**Re: Customer Reference No 4995161937 pre-connection enquiry - Subject to contract | Contract denied
[Connection for Strategic Housing Development of 650 no. domestic units]**

Irish Water has reviewed your pre-connection enquiry in relation to water and wastewater connections at Beechpark, Scholarstown Road, Rathfarnham, Dublin

Re: Design Submission for Beech Park, Scholarstown Road, Rathfarnham (the “Development”) (the “Design Submission”) / 4995161937.

DBFL Consulting Engineers
 Unit 10, The Old Mill, The Quay, Dublin 1, Ireland
 Phone: +353 1 400 4000
 Website: www.dbfl.ie
 Project Ref: RESIDENTIAL DEVELOPMENT SCHOLARSTOWN
 Drawing Title: SITE SERVICES LAYOUT
 Designed by: JB
 Scale: 1:500
 Sheet Size: A0
 Drawing No: SCH-DBF-ZZ-XX-DR-C-3102

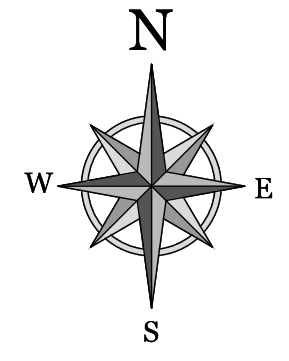
We have reviewed your proposal for the connection(s) at the Development. Based on the information provided, which included the documents outlined in Appendix A to this letter, Irish Water has no objection to your proposals.

This statement of design acceptance to all necessary existing water mains and sewer line being rerouted and agreed with the Irish Water Diversion team.
